[Docket No. NHTSA-2019-0017]

Nuro, Inc.; Receipt of Petition for Temporary Exemption for an Electric Vehicle With an Automated Driving System

ACTION: Notice of receipt of petition for temporary exemption; request for public comment.

Figure 1. Picture of R2X (Source: <https://nuro.ai/product/>)

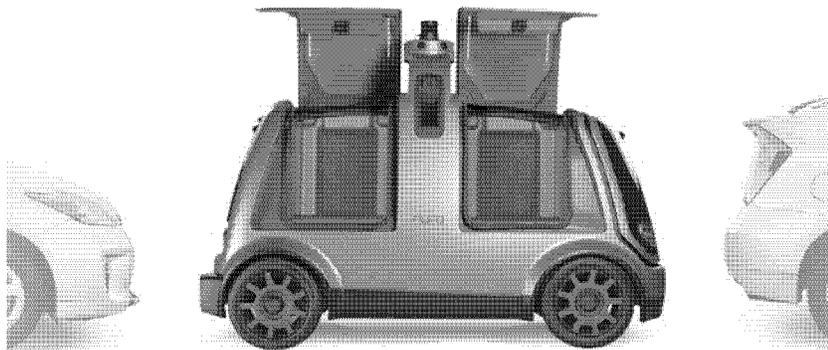
weight" is its unloaded weight, whereas a vehicle's GVWR is its loaded weight rating as specified by the manufacturer.) We note that Nuro does not provide the precise GVWR of the R2X, which is needed to determine whether the R2X would properly be classified as an LSV.

14. Did Nuro provide sufficient information about how the R2X would interact with human-controlled vehicles on the road? Should the agency be concerned about the front-end stiffness of the R2X and its impact on collision partners?

21. Would the pedestrian safety features described in the petition (rounded edges, pedestrian "crumple zones") be effective in the environment in which the R2X would be used? Can the effectiveness of these measures be validated? If so, should NHTSA require Nuro to provide testing data to demonstrate the effectiveness of these measures?
